## REVISED RESPONSE TO REQUEST FOR ADDITIONAL INFORMATION

### APR1400 Design Certification

Docket No. 52-046

RAI No.: 227-8274  
SRP Section: 03.08.04 – Other Seismic Category I Structures  
Application Section: 03.08.04  
Date of RAI Issue: 09/25/2015

Figure 3.8A-40 Reinforcement Arrangement of the AB MSIV House Wall (Section 1)

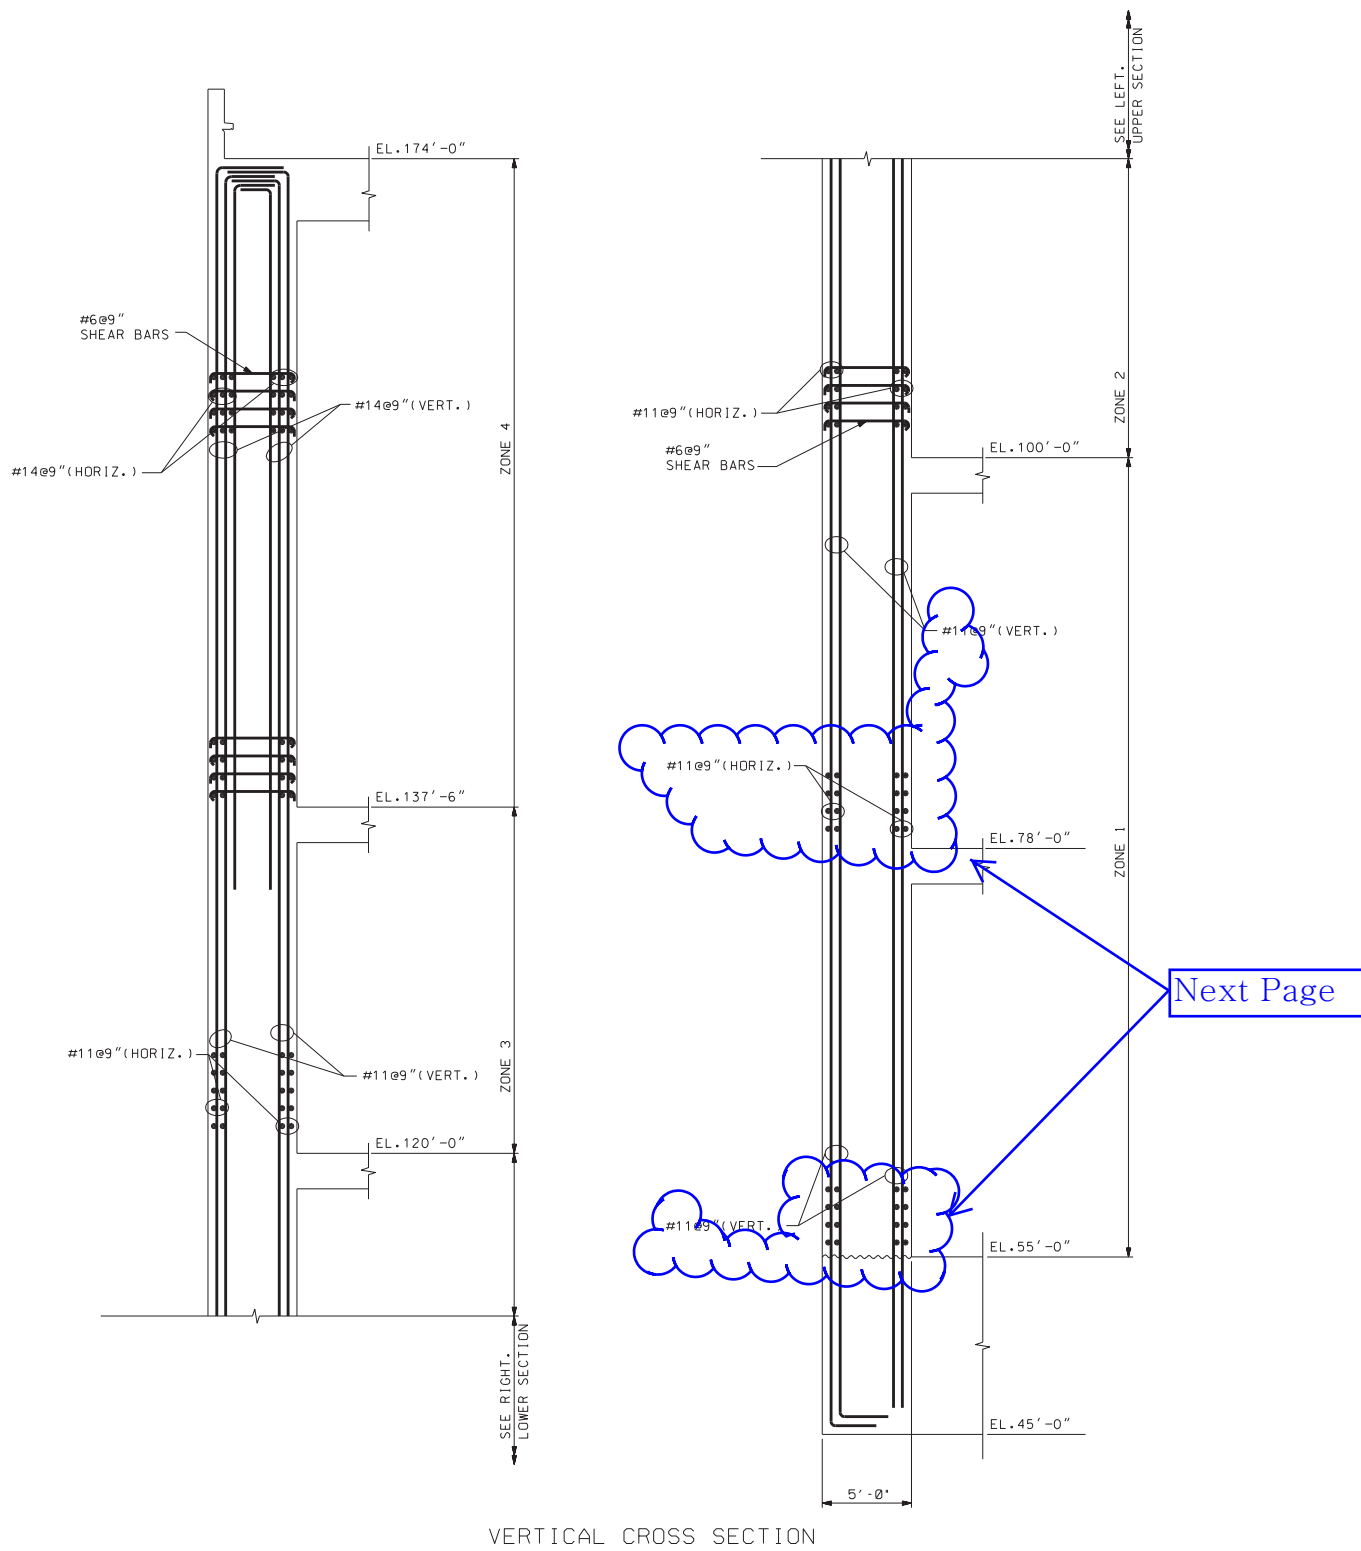
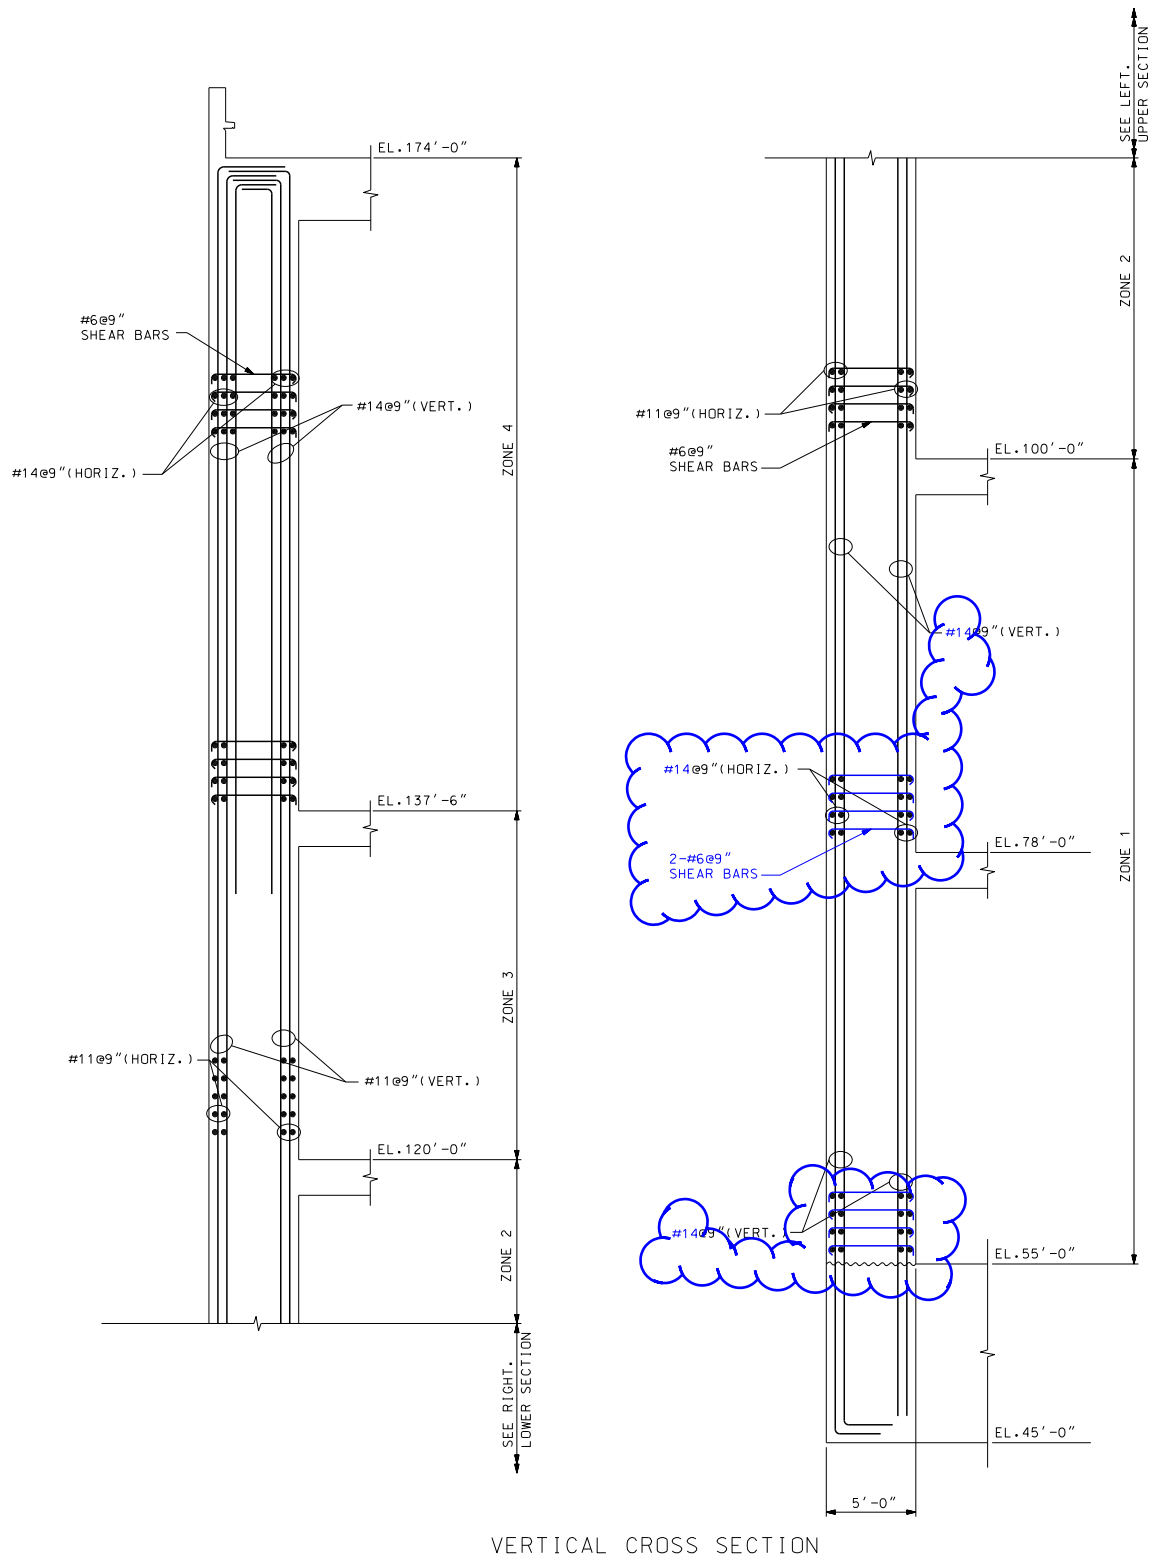
a) Applicant is requested to describe how all walls below grade were analyzed and designed for dynamic lateral earth pressures for all structures, and if the approach was consistent with that described in SRP 3.8.4 II.4.H. If not, provide the basis for using the alternative approach. In addition, for the calculation of the hydrodynamic effect of pure water, determined based on the hydrodynamic formula suggested by Matsuo and O'Hara, the formula used should be provided and the full reference designation for this, as well as any other references discussed in the DCD should be identified in the DCD.

Based on the revised analyses, the dynamic earth pressures determined from the SSI and SSSI analyses are the governing case. Therefore, the structural analysis of the Auxiliary Building was revised using the governing dynamic earth pressure obtained from the SSI and SSSI analyses. Based on the results of the revised structural analysis, the structural member forces of the exterior walls below grade level were determined, and the design of these exterior walls was evaluated again. Consequently, the increased dynamic earth pressure led to an increase in the amount of reinforcement steel required in the Auxiliary Building walls. Therefore, Tables 3.8A-28, 3.8A-29 and Figures 3.8A-40, 3.8A-41, 3.8A-43, 3.8A-44 will be revised as shown in Attachment 3 associated with this response.

DCD Tier 2 Subsections 3.8.4.3.4, 3.8.7, 3.8A.2.4.2, 3.8A.3.4.2 and Tables 3.8A-28, 3.8A-29 and Figures 3.8A-40, 3.8A-41, 3.8A-43, 3.8A-44 will be revised as indicated in the attached markup.
